## FIELD OBSERVATION REPORT

Lincoln Trail Elementary School, Hardin County Schools, Elizabethtown, KY 201752 -CA8

Report No: 26

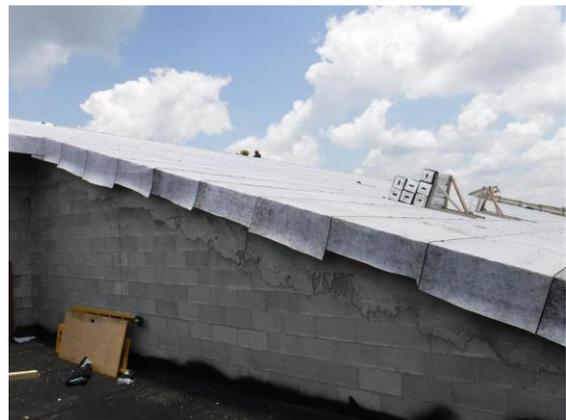
With the roof over Area B still incomplete and entry areas of the building open, there are still ample places for storms to flood the building. Until the roofing, windows and entries are in place, the building will not be completely dried in thus slowly finished interior work.

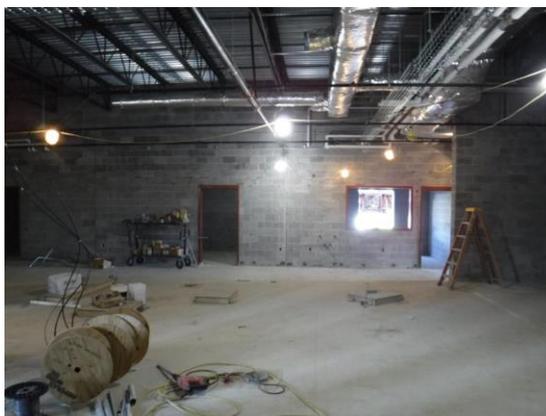
- q) Masonry workers were detailing the block in the Gym. The lack of temporary lighting makes it difficult for the workers to see their work and for the architects and engineers to inspect the work.

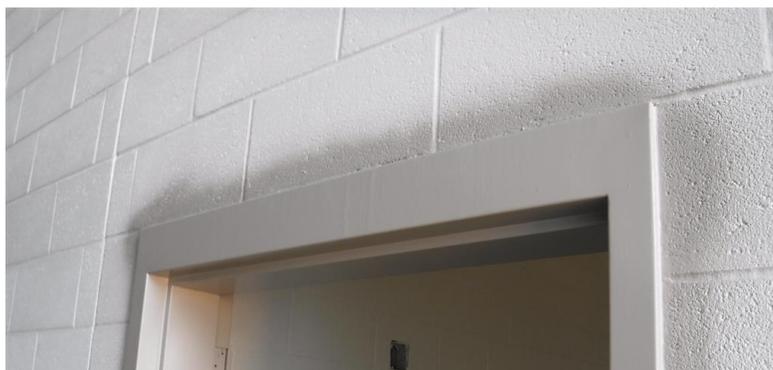
- u) This frame for Resource 143 will need to be sanded and repainted.

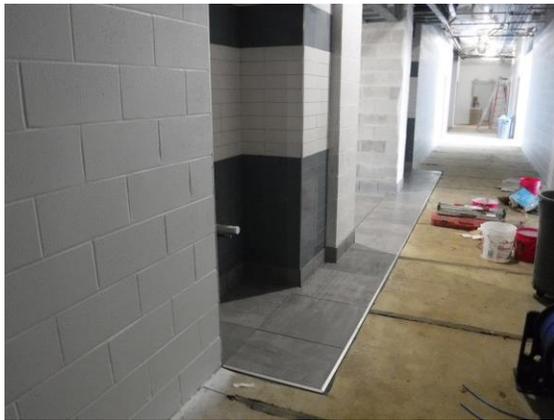
- w) The painter complained that the control joints were not properly prepared by the mason. I agree with the painter. The joints are not straight, not even and filled with mortar. This needs to be corrected before the joints are caulked.
